MONTGOMERY COUNTY PLANNING DEPARTMENT
 THE MARYLAND-NATIONAL CAPITAL PARK AND PLANNING COMMISSION

MEMORANDUM

PROJECT NAME: Woodmont East – Phase II

REVIEW TYPE: Project Plan

Architectural Concept

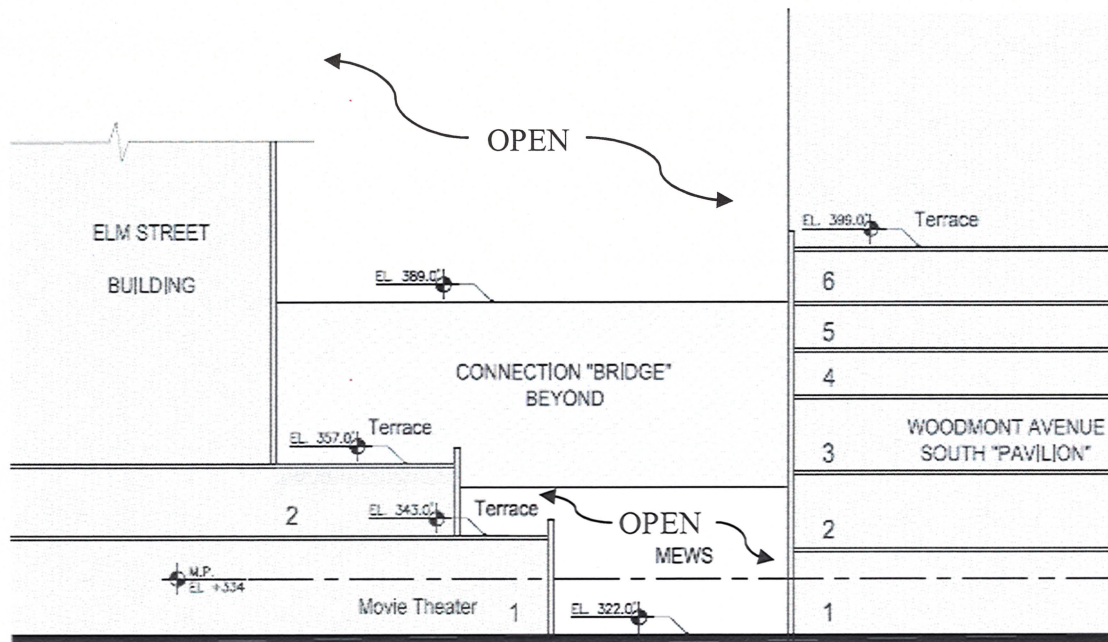
The original design proposed a 50-foot wide bar three stories above the Purple Line easement and Georgetown Branch Trail. This bar was located midway between the proposed building's northern and southern components and was felt to create a space that was overwhelmed by the mass and cut-off from light and air. The current design addresses this issue by moving the

connection to the eastern edge of the site and reducing its width and mass. The connection now functions more like a bridge and will include roof-top uses such as a terrace or patio for guests or patrons. It will also house the mechanical connections and a couple levels of hotel rooms or residences, but will no longer rise to the full height of the adjacent components. Along with the terrace above the building's southern component, these rooftop "living spaces" will create interest and activation in three dimensions and diminish the perceived mass of the building. The underside of the bridge will become a canvas for artwork that will become an attraction in its own right.
